REMARKS

AMENDMENTS TO THE DRAWINGS

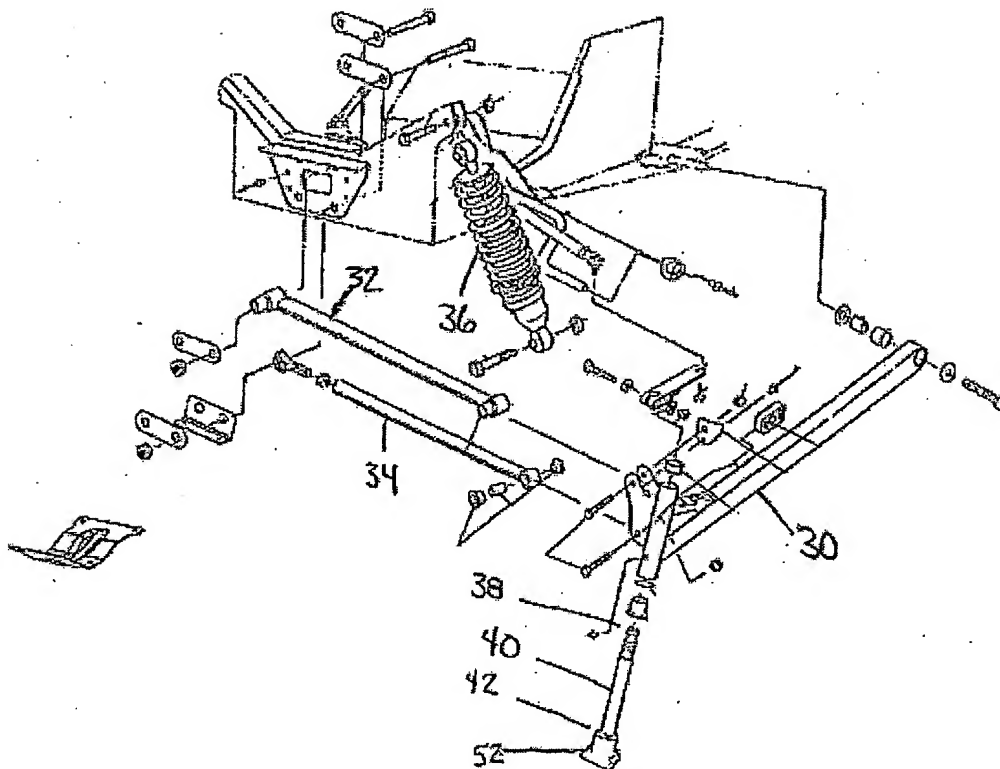
Figure 4 has been amended to more clearly show the central point 77 between the first end 70 and second end 72 of the bushing 66. No new matter has been added to the application, as this information was already contained implicitly and explicitly within the specification and figures.

The specification has been amended to add reference number 77 for a central point between the first end 70 and the second end 72 of the bushing 66 within the final paragraph on page seven. Reference number 77 was also amended in Figure 4 to clearly call out the central point claim element. No new matter has been added to the application, as this information was already contained implicitly and explicitly within the specification.

Fig. 2
Prior Art

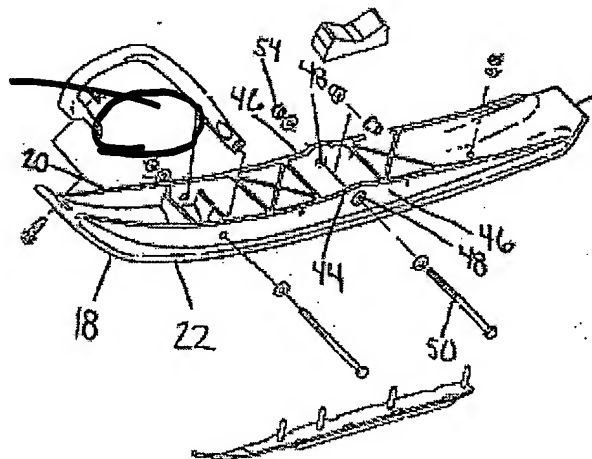
Figure 2 was objected to for having reference numbers that did not appear in the disclosure. Figure 2 has been amended to remove the reference numbers not identified in the disclosure and to remove the short lead line pointing towards a rectangular shaped object on the far left hand side of Figure 2.

Note:
Deletion
